TECHNICAL MEMORANDUM

SUBJECT: Sensitivity Analysis for Recommended Improvements for the Cities of Ceres

and Turlock Local Distribution Systems to Integrate the Stanislaus Regional

Water Authority Surface Water Supply Project

Figure 2 Ceres Sensitivity Analysis Revised Infrastructure for Phase 1

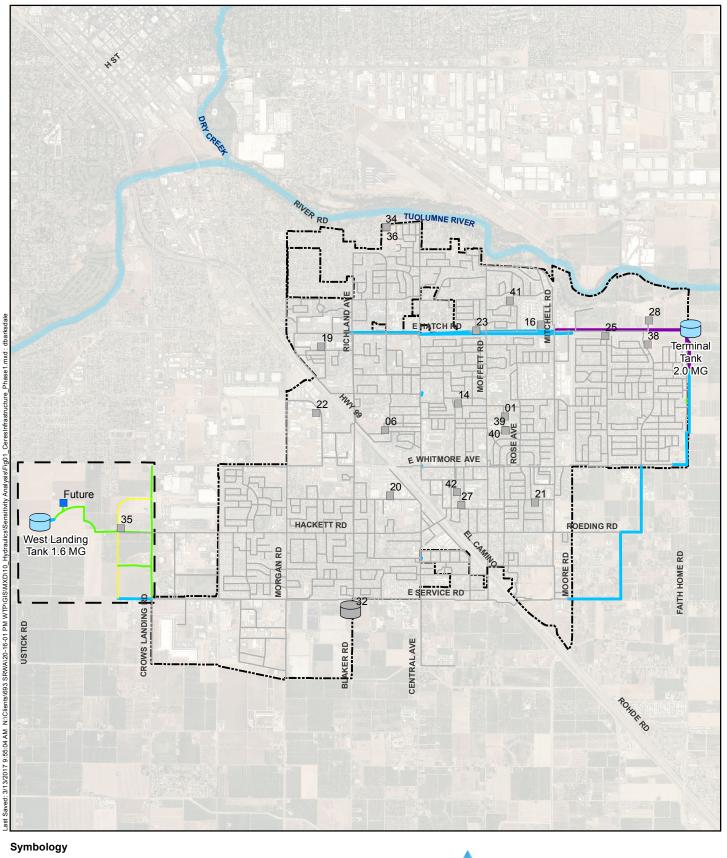
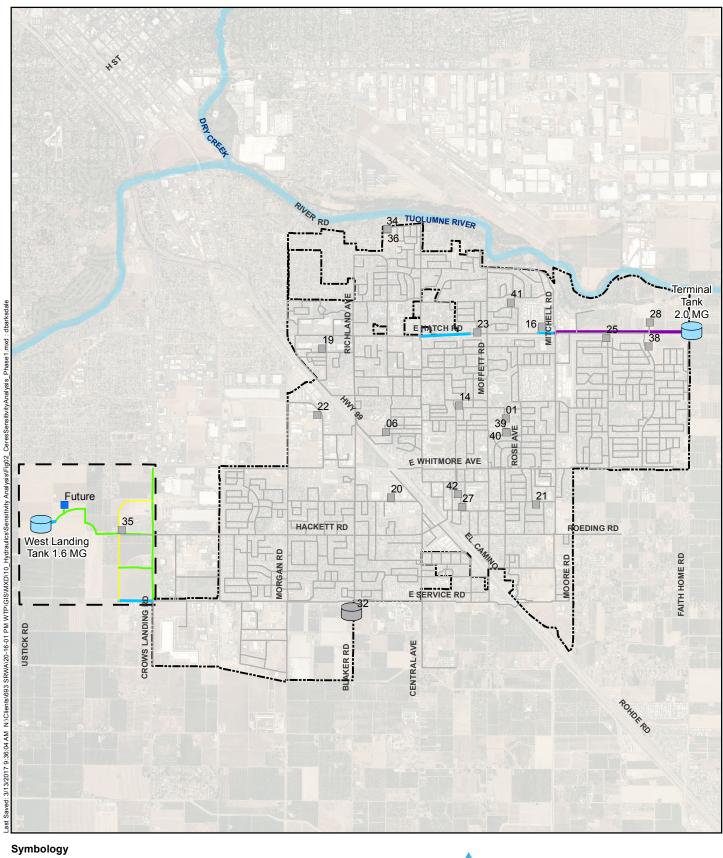
Ceres requested a hydraulic system sensitivity analysis to determine whether 10 mgd could be delivered by only installing pipelines in the current pipeline gaps along East Hatch Road. A sensitivity analysis was conducted for the 2025 maximum day demand scenario with a 24-inch pipeline from the Terminal Tank to the existing 12-inch diameter and 8-inch diameter pipeline on East Hatch Road, east of Mitchell Road, and completing gaps west of Mitchell Road connecting 16-inch diameter pipelines to existing 10-inch diameter pipelines.

The sensitivity analysis found just installing pipelines to fill the pipeline gaps did not provide sufficient water system capacity. A new, continuous, 24-inch diameter pipeline from the Terminal Tank to Mitchell Road must be installed to provide adequate system pressure. With this configuration, pressures can be maintained between 40 psi and 60 psi in most of the system, with a few areas along East Hatch Road east of Mitchell Road above 60 psi, up to 67 psi.

Figure 2 shows revised infrastructure requirements identified in the sensitivity analysis.

Ceres Sensitivity Analysis Revised Infrastructure for Phase 2

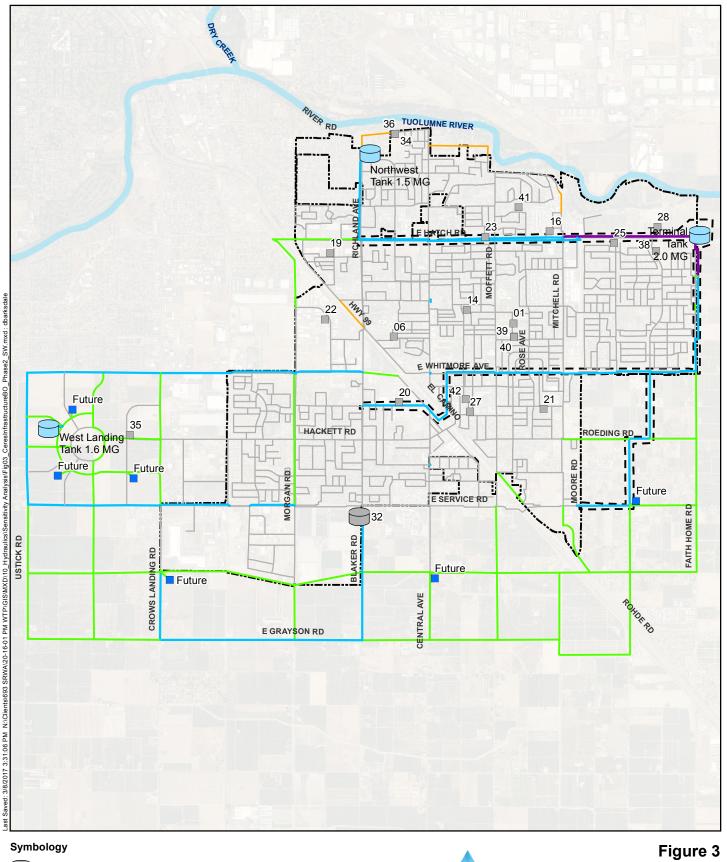
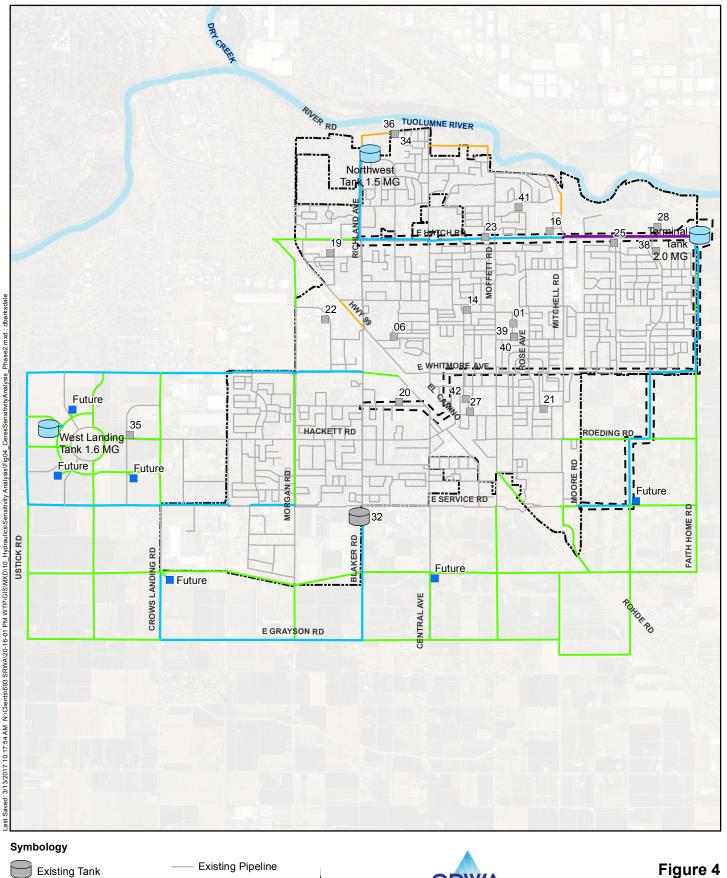
A sensitivity analysis for 2035 maximum day demands identified the following infrastructure revisions (see Figure 4):

- Eliminate the 16-inch diameter pipeline on Whitmore Avenue. There are still two large-diameter crossings of Highway 99, one 16-inch on Richland and one 24-inch diameter on Service Road; and
- Downsize the short length of 24-inch diameter pipeline on Faith Home Road near East Hatch Road to 16-inch diameter.

These improvements result in system pressures generally between 40 and 60 psi, with slightly higher pressures near the Terminal Tank connection to the system. The highest system pressure is 68 psi.

The sensitivity analysis was reviewed in a workshop with Ceres on February 2, 2017. Ceres requested using revised infrastructure recommendations from the sensitivity analysis for cost estimates being developed for the Project. Table 1 summarizes project improvements.

Figure 6 Turlock Sensitivity Analysis for Phase 1

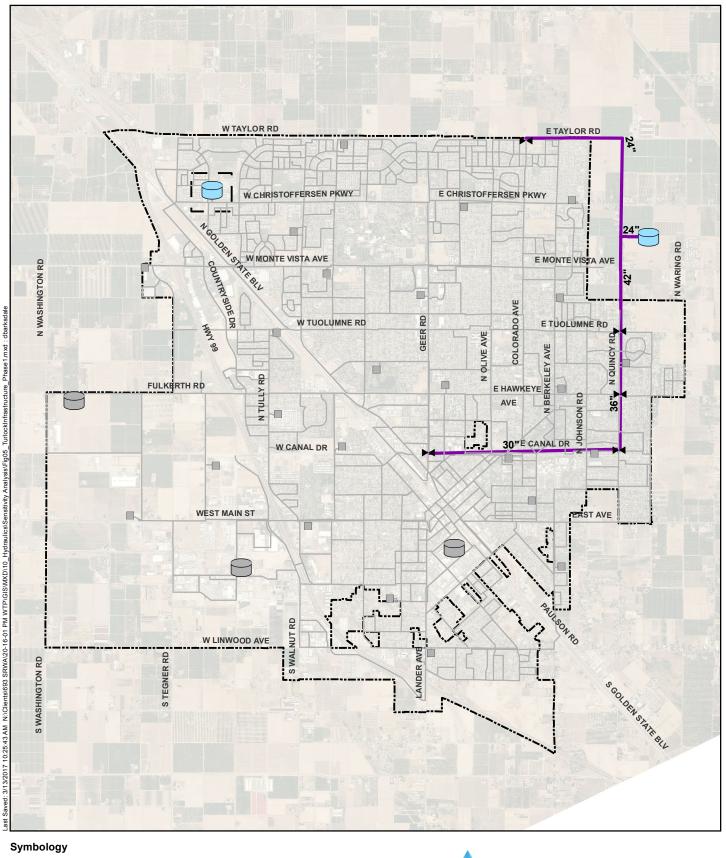
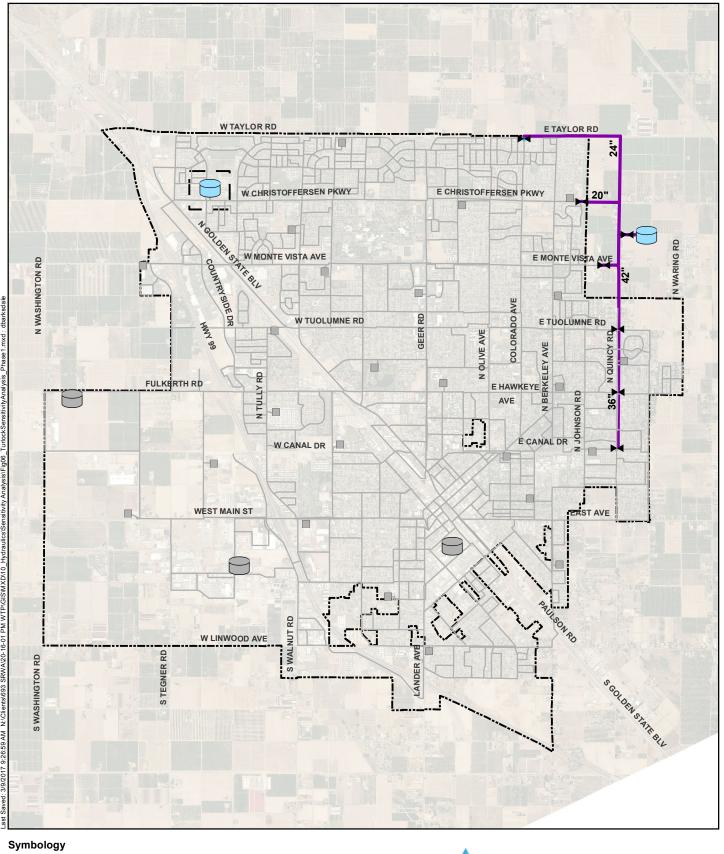
Turlock requested a sensitivity analysis to determine whether 20 mgd could be delivered by completing only the 42-inch diameter portion of the pipeline along North Quincy Road, from Tuolumne Road north, and the pipeline along East Taylor Road from North Quincy Road to Colorado Avenue. They also suggested adding new turnouts at Christofferson and Monte Vista.

The sensitivity analysis found that the pipeline on Quincy Road south of Tuolumne Road is also needed, but that the Canal Drive pipeline could be eliminated (Figure 6). With this configuration, system pressures generally range from 40 to 60 psi, with a few locations with pressures up to 65 psi.

Turlock Sensitivity Analysis for Phase 2

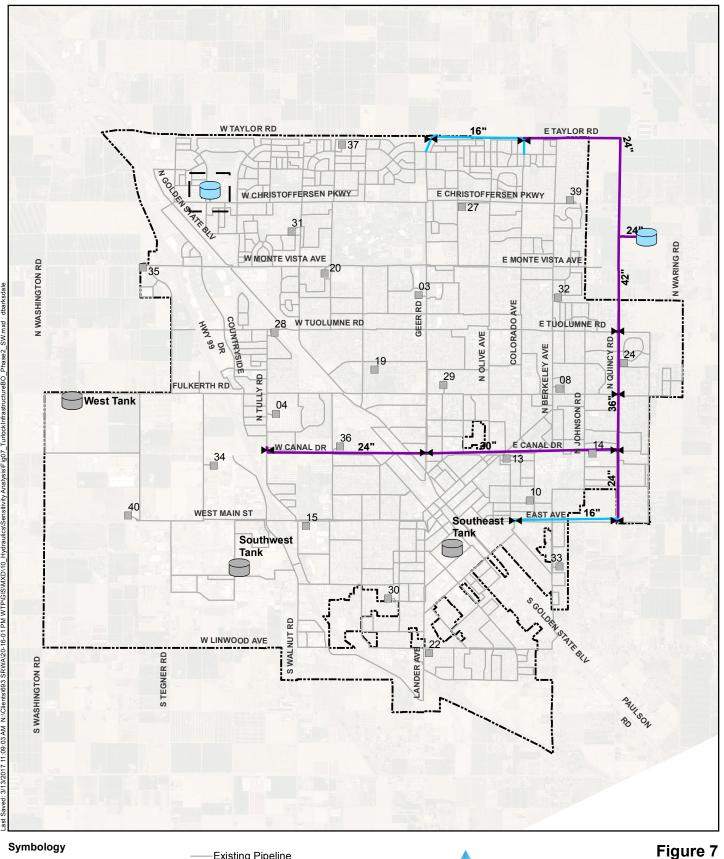
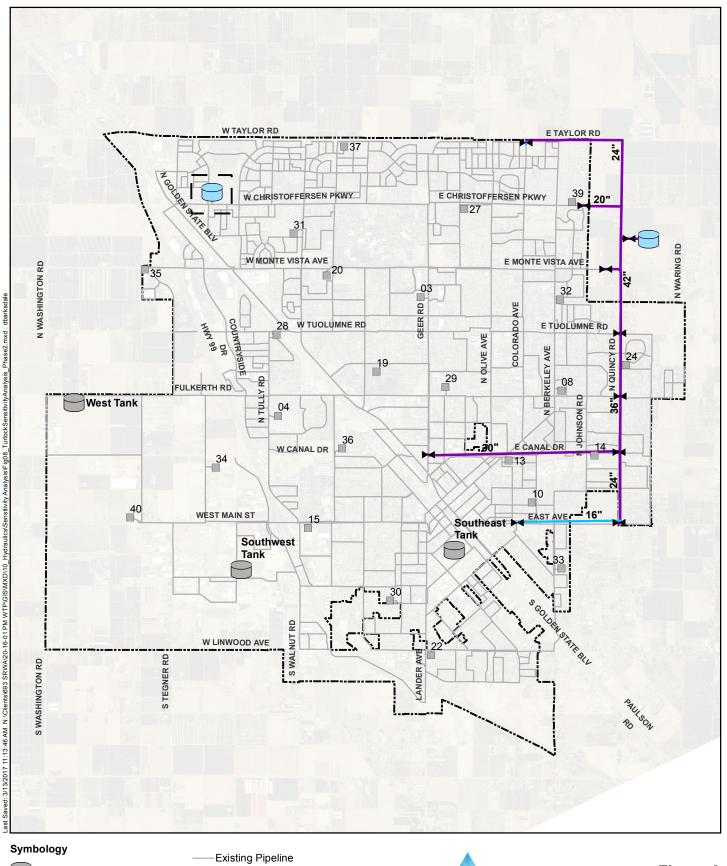
A sensitivity analysis for 2040 maximum day demands identified the following possible infrastructure revisions (see Figure 8):

- Elimination of the 16-inch diameter pipeline on East Taylor Road, and
- Elimination of the 24-inch pipeline along West Canal Drive.

These improvements result in system pressures generally between 40 and 65 psi, with a few locations in the southwest part of the system marginally below 40 psi (39 psi lowest pressure).

The sensitivity analysis was reviewed in a workshop with Turlock on January 26, 2017. Turlock opted to continue using infrastructure recommendations from November 2016 TM for cost estimates being developed for the Project.
